**REVISED
PLANNING AND ZONING COMMISSION**

**6715 Sawmill Road
Concept Plan**

4. Germain Honda, Phase IV 20-184PDP **6715 Sawmill Road Preliminary Development Plan**

3. Germain Honda, Phase IV at 6715 Sawmill Road 21-031FDP Final Development Plan

PROPOSED SITE PLAN

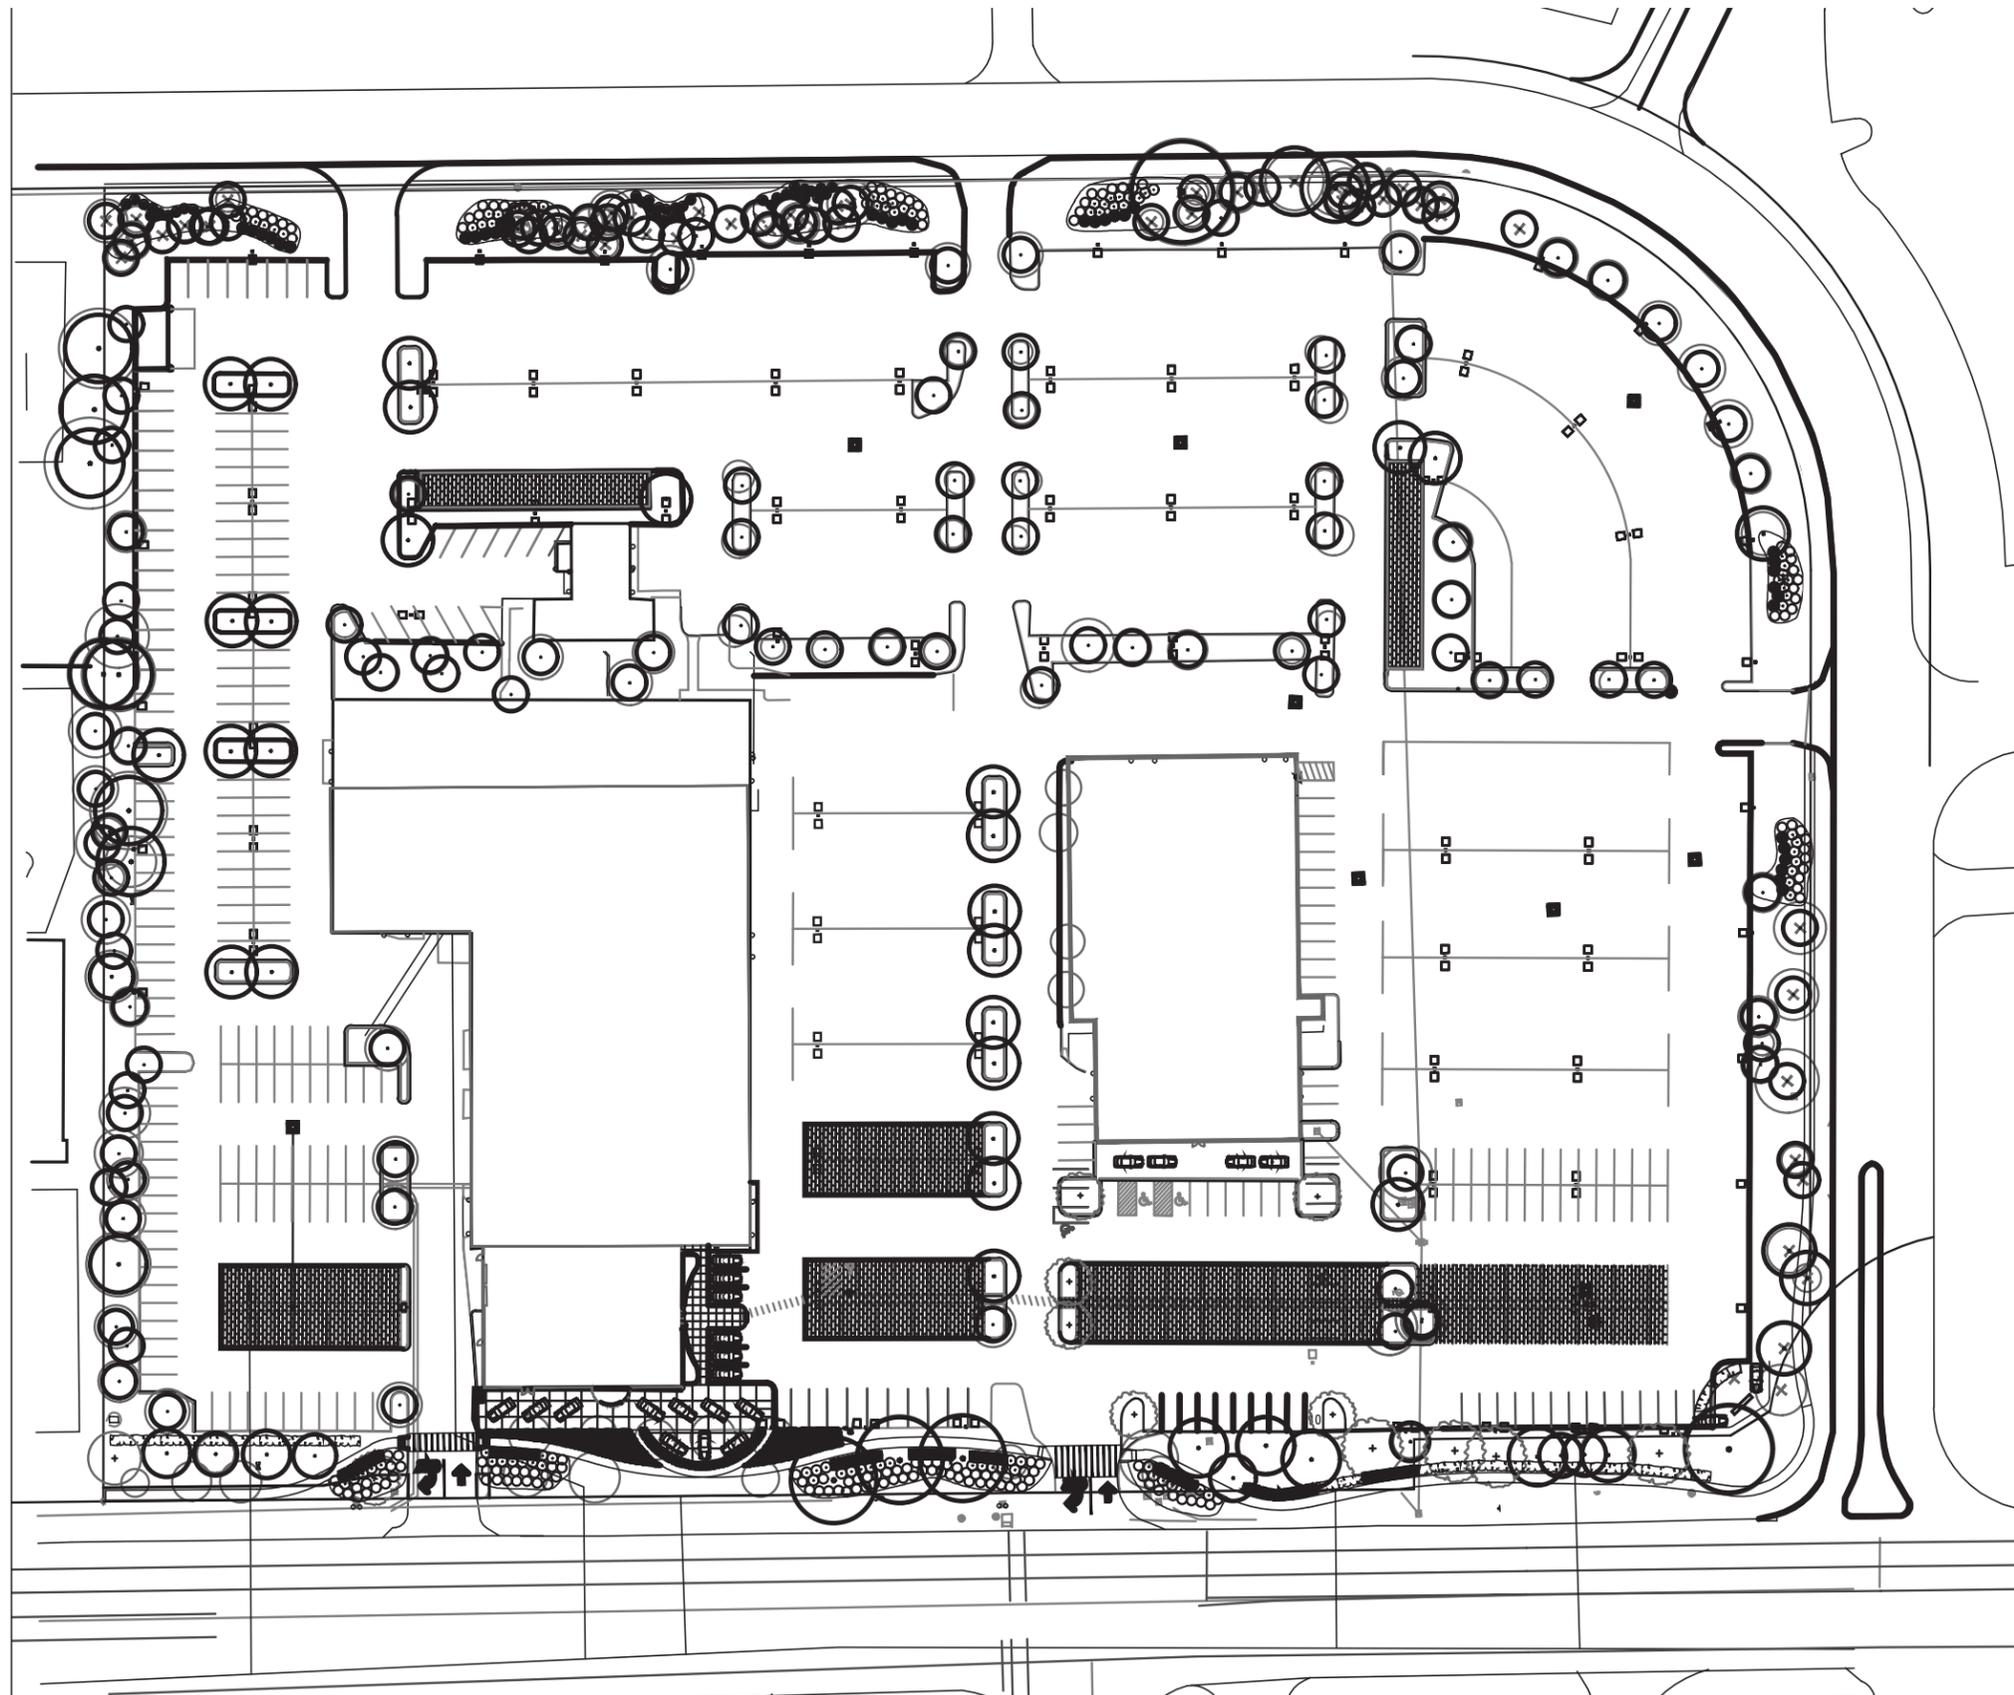
Mr. Way stated that he has a question about raising the height of the stonewall from 30 to 33 inches to hide the vehicle display area. Part of the stonewall is located on top of concrete, and is only 1 foot, 6 inches in the car display area. Where would a 33-inch wall be?

Mr. Way stated that he did not see a plan that depicted the layout of the bollards in relationship to the display area. Are they located inside the stone wall on the vehicle display area?

- 1) That the applicant work with Staff to ensure all lighting requirements of the Code are met and the light level along Sawmill Road are subdued, subject to Staff approval;
- 2) That the street wall height be increased from 30 inches to 33 inches;
- 3) That the applicant work with Staff to select decorative bicycle racks, outdoor seating, and a waste receptacle, subject to Staff approval; and
- 4) That the applicant work with Staff to replace or remove the gates located at the entrance along Dublin Center Drive.
